From: David Tovani davidt@accion-systems.com 
Subject: RE: IRVINE02 FCC - Responses
Date: August 21, 2018 at 4:31 PM
To: Brent Freeze brent.freeze@gmail.com, Alicia Irene Johnstone aijohnst@calpoly.edu
Cc: jennifer.blackie@iusd.org, John Bellardo bellardo@calpoly.edu

Here are Accion's responses:

Figure shows sublimation mass over time - X axis is time and Y axis is sublimated mass.

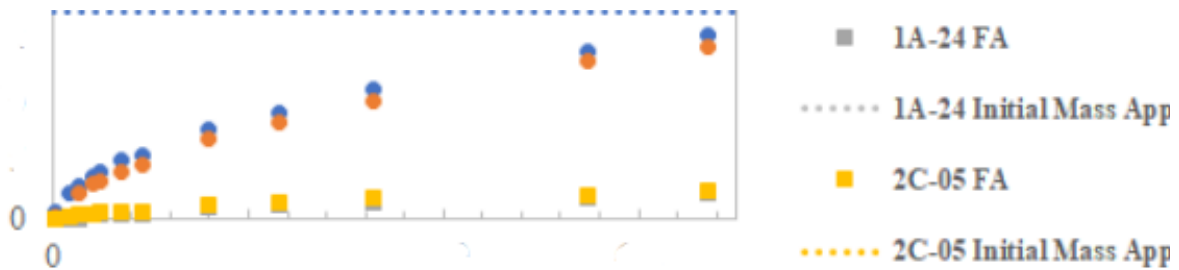
- test results are useful but maybe some additional analysis would be helpful as well
 - Additional humidity tests were added to the test summary previously sent (attached, bottom row). To date, on over 50 test articles that match the IRVINE02 design, we have not identified a leak through this barrier. Sublimation of the barrier material show predictable rates during vacuum tests using the same material used on IRVINE02. The graph below illustrates the predictable nature of two sublimation materials on 4 thruster samples.
